PAYLOAD FLIGHT HAZARD REPORT		a. NO:	AMS-02-F09
b. PAYLOAD	Alpha Magnetic Spectrometer-02 (AMS-02)		c. PHASE: II
d. SUBSYSTEM:	Radiation	e. HAZARD GROUP:	Radiation, Injury/Illness

f. DATE:	May 22, 2006
g. HAZARD TITLE:	Exposure of the Crew to Excessive Ionizing Radiation		i. HAZARD CATEGORY: CATASTROPHIC X CRITICAL
h. APPLICABLE SAFETY REQUIREMENTS:	NSTS 1700.7B and ISS Addendum, paragraphs: 200.2, 212.1

Ionizing Radiation Source Review Response

From: JSC Radiation Constraint Panel/Radioactive Payloads Working Group (RCP/RPWG)
To: SD4 / M. E. Coleman
 NS2 / PSRP Executive Secretary
Subject: Assessment of Crew Risk from Exposure to Radioactive Material / Radiation Producing Equipment

Figure 1: AMS-02 TRD Calibration Tube

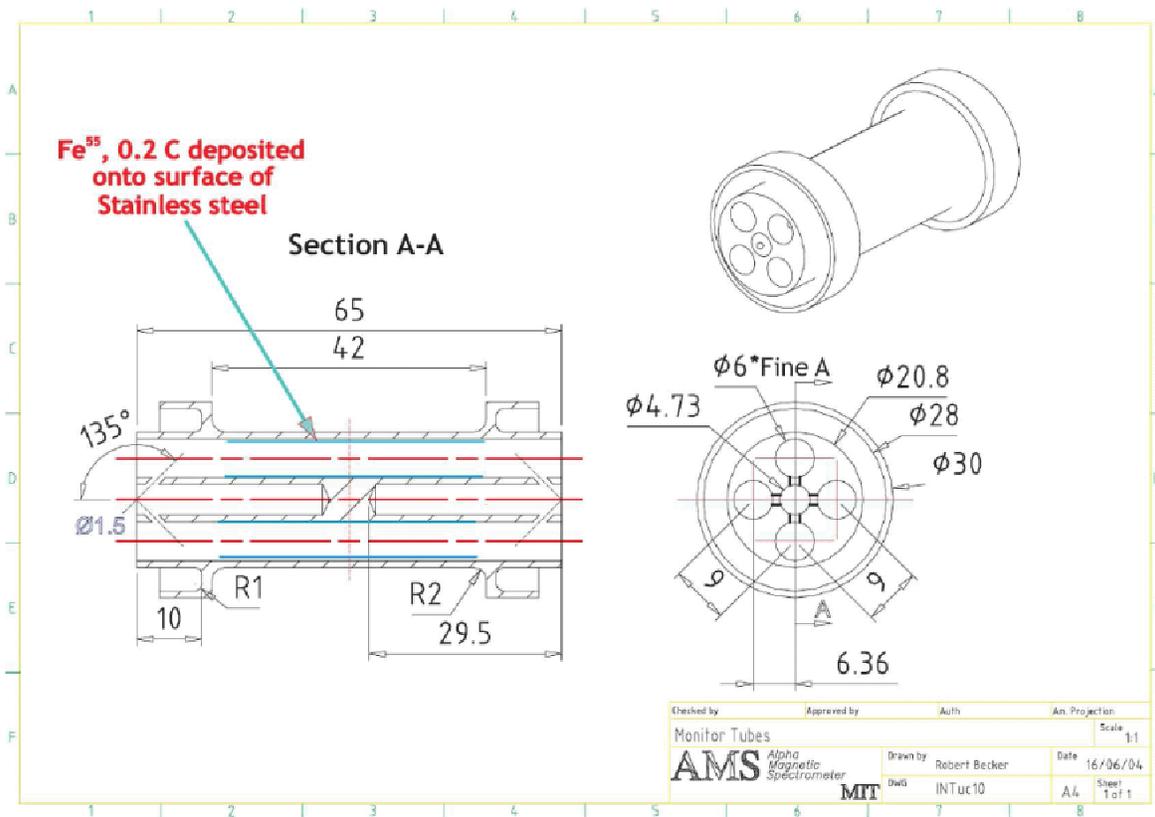
B. Additional Comments
 Please note that the value of the Fe-55 source given in Figure 1 is not correct. The true values per tube is ~0.03 microCi. Due to the small activity level, low energy, and no crew involvement, these sources pose no radiologic risk to the crew or vehicle.
